# ORIGINATION FORM

Index Number: 521-405  
Sheet Number (s): 1  
Index Title: Guardrail Transitions- Existing Post & Beam  
Bridge Railings (Wide Curbs)

GUARDRAIL TRANSITIONS - EXISTING  
POST & BEAM BRIDGE RAILINGS (WIDE CURBS)

INDEX  
521-405

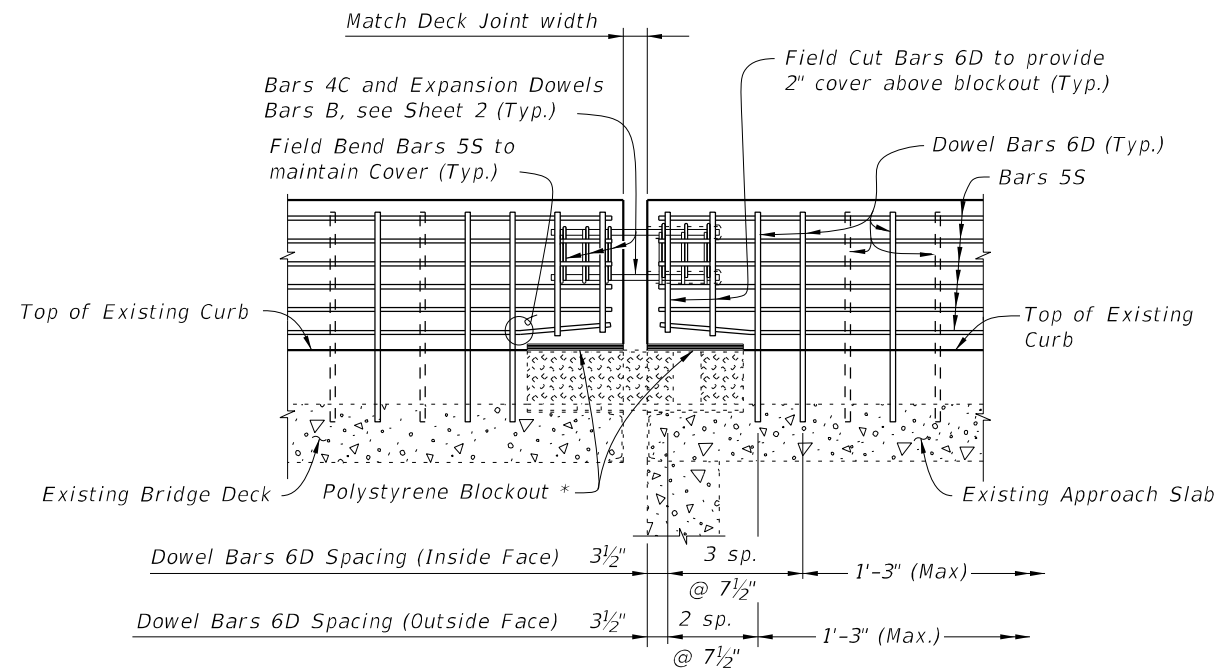
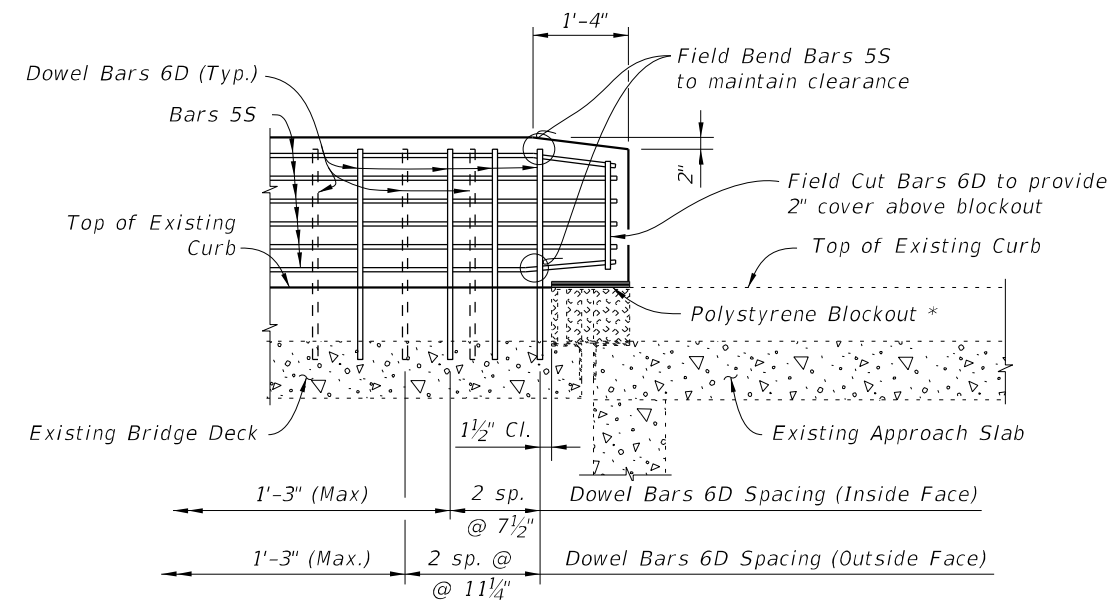
Changed Payment Note

Updated payment to match the BOE

**PAYMENT:** Concrete Traffic Railing - Bridge Retrofit - Post & Beam Railing (each) includes all materials and labor required to demolish a portion of the existing structure where required and to construct the concrete portion of the retrofit railings. Guardrail ~~Bridge Anchorage Assembly (each)~~ includes all ~~barrier delineators for the entire bridge length,~~ transition blocks, and necessary hardware to complete the Guardrail transitions shown.

Approach Transition to Rigid Barriers (EA)

**PAYMENT:** Concrete Traffic Railing - Bridge Retrofit - Post & Beam Railing (each) includes all materials and labor required to demolish a portion of the existing structure where required and to construct the concrete portion of the retrofit railings. Guardrail Approach Transition to Rigid Barriers (EA) includes all transition blocks, and necessary hardware to complete the Guardrail transitions shown.
